# Access Compliance Report
# Public Rights-of-Way
# (Curb Ramps)

**Main Street: TRIAD_LN** | **Cross Street: ETON_PL** | **Location: NE**

**ADA ID: RPRK211028120727** | **Ramp Type: Type 4 - Parallel** | **Initial Pass/Fail: Fail** | **Overall Compliance: No** | **Severity Score: 2**

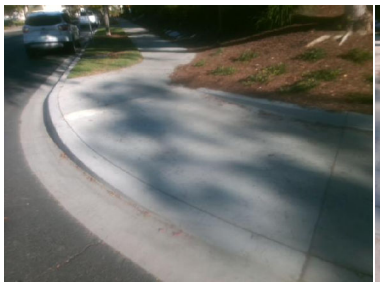
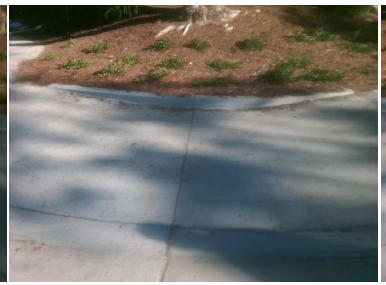
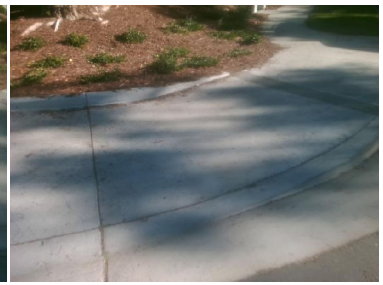
| Compliance | Description | Data | Compliance | Description | Data |
|---|---|---|---|---|---|
| **Yes** | Ramp Cross Slope LT (%) | **1.2** | **No** | Ramp Cross Slope RT (%) | **3.5** |
| **N/A** | Gutter Ponding | **N/A** | **No** | Curb Slope | **10.3** |
| **N/A** | Gutter Cross Slope (%) | **N/A** | **No** | Perpendicular Joint Present | **No** |

**Remove & Replace Curb Ramp With Two New Directional Ramps or Equivalent.**
